# Team Update 01

### Section 2 Game Overview

Figure 0-1 TRENCH bottom view

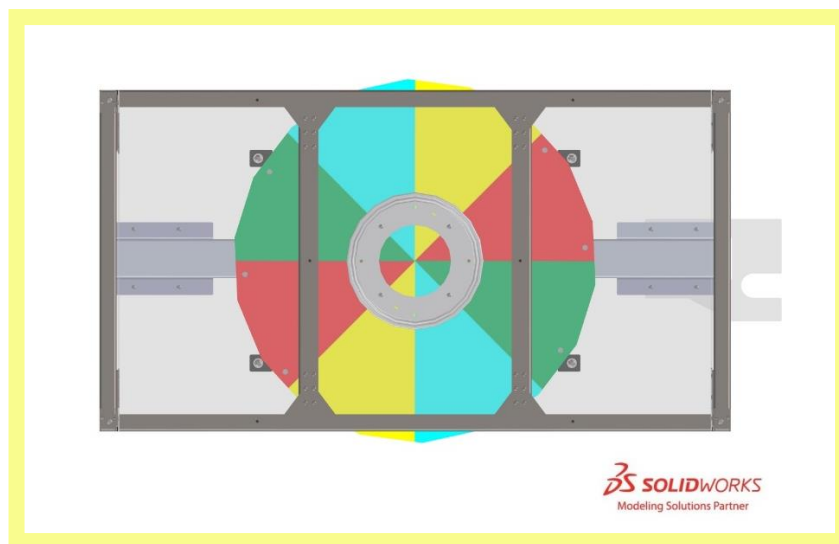
- *FIRST* Official CAD Models, updated at 5pm on 1/2/2020
    - Updated location of TRENCH
  - Layout and Marking Diagram, updated at 5pm on 1/2/2020
    - Updated location and dimensions associated with TRENCH

Figure 0-2 POWER PORT Vision Target

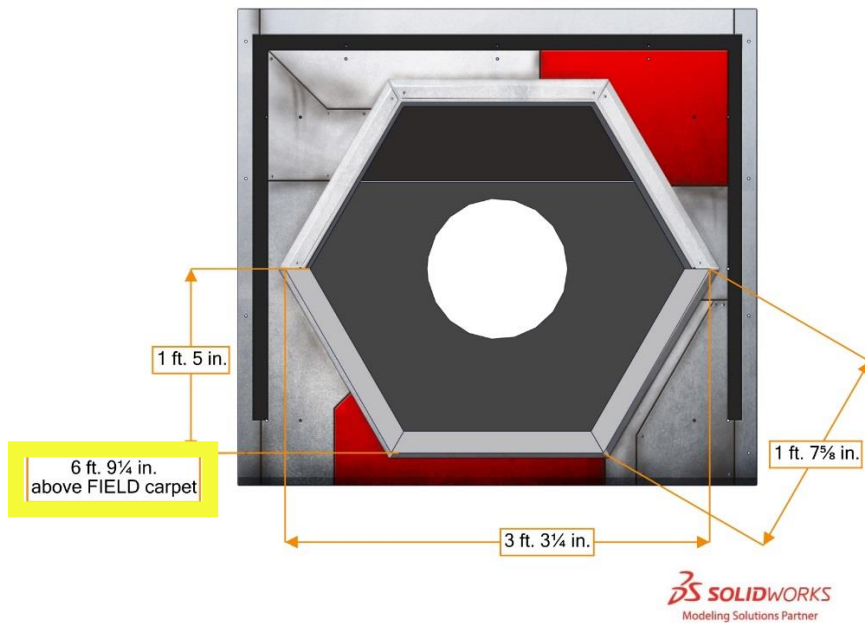
Vision targets made from 2 in. (~5 cm) wide strips of 3M 8830 Scotchlite™ Reflective Material are located on the POWER PORTS and LOADING BAYS. On the POWER PORT, they target the location of the INNER and OUTER PORTS and trace the bottom perimeter of the OUTER PORT. The target has an overall height of 1 ft. 5 in. (~43 cm), and a width of 3 ft. 3¼ in. (~100 cm). The bottom of the target is 6 ft. 9¼ in. (~206 cm) above the carpet. A strip of 3M 8830 Scotchlite™ Reflective Material is in each Black Tote of the [2020 Kickoff Kit](#) **FIRST Choice**.

Figure 7-4 Examples of G18 compliance and non-compliance

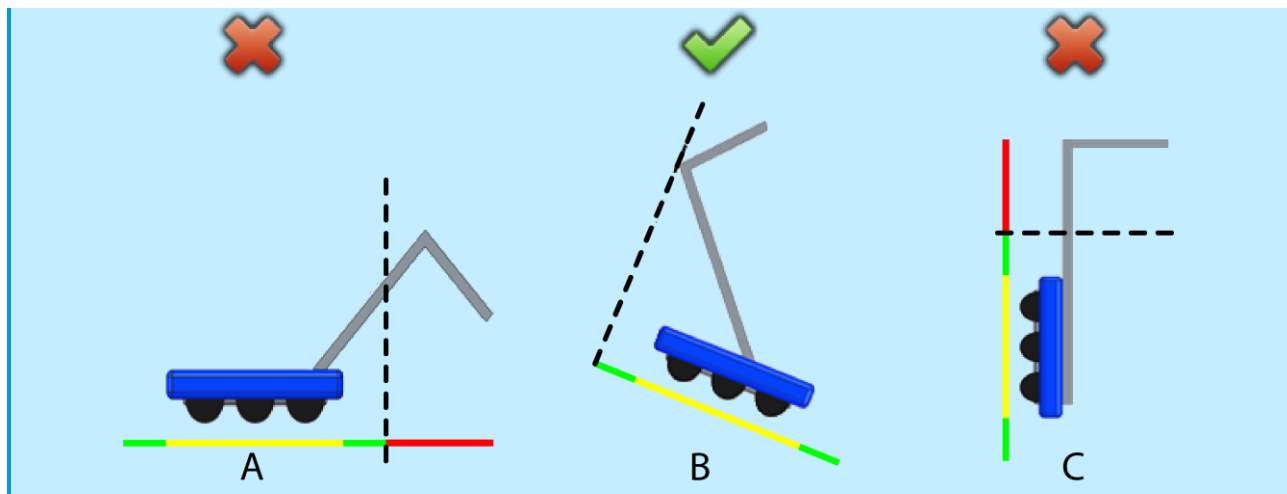
Examples of compliance and non-compliance of G18 are shown in Figure 7-4.

Yellow bars represent the limits of the FRAME PERIMETER and are drawn in the same orientation of the ROBOT'S FRAME PERIMETER. Green bars represent a measured extension from the FRAME PERIMETER that does not violate G18. Red bars represent a measured extension from the FRAME PERIMETER that exceeds the limit in G18). ROBOTS A and C violate G18, whereas ROBOT B does not.

Figure 0-1 POWER CELL movement limitations

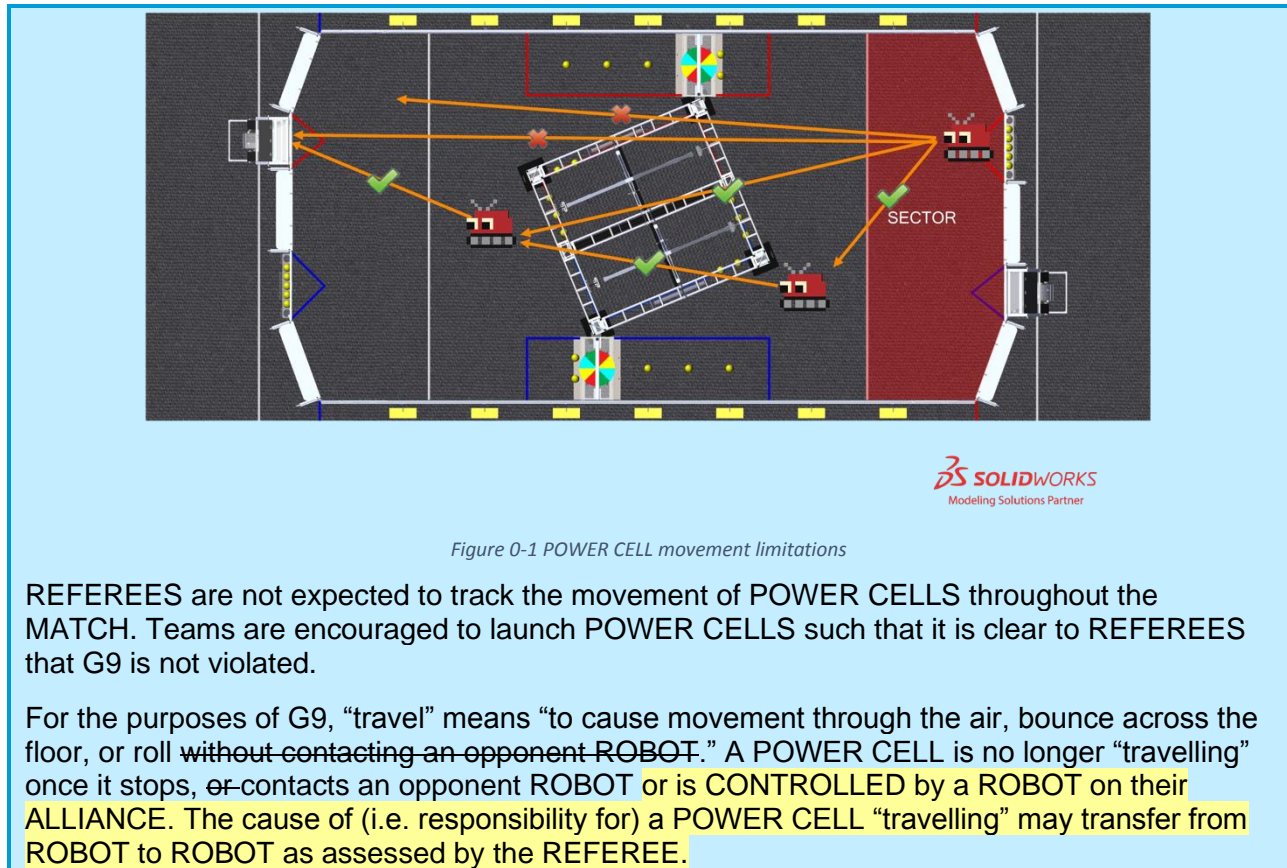
**G9. No full court shots.** A ROBOT whose BUMPERS are fully contained by their SECTOR may not cause POWER CELLS to travel into or through their opponent's SECTOR.

REFEREES are not expected to track the movement of POWER CELLS throughout the MATCH. Teams are encouraged to launch POWER CELLS such that it is clear to REFEREES that G9 is not violated.

For the purposes of G9, “travel” means “to cause movement through the air, bounce across the floor, or roll without contacting an opponent ROBOT.” A POWER CELL is no longer “travelling” once it stops, or contacts an opponent ROBOT or is CONTROLLED by a ROBOT on their ALLIANCE. The cause of (i.e. responsibility for) a POWER CELL “travelling” may transfer from ROBOT to ROBOT as assessed by the REFEREE.

Image from the laminated field layout on left, image from actual field on right

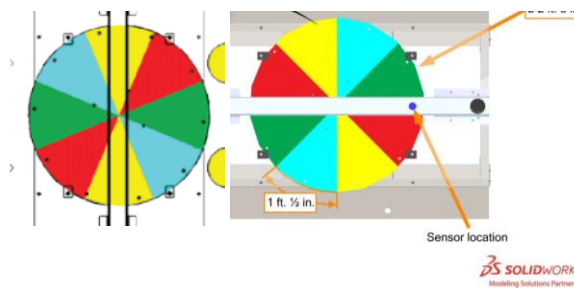
FIRST Choice Round 2 orders continue to ship (we thank you for your patience!). For those of you who have received them, you've probably noticed a bonus item included in each shipment; a laminated field layout w/ dry erase marker. Thank you to Piedmont Plastics for the strategic donation. We want to let you know that the color pattern on these boards (shown on the left below, clockwise: Y, R, G, and B) are the opposite of the actual field (shown on the right below, clockwise: B, G, R, and Y).
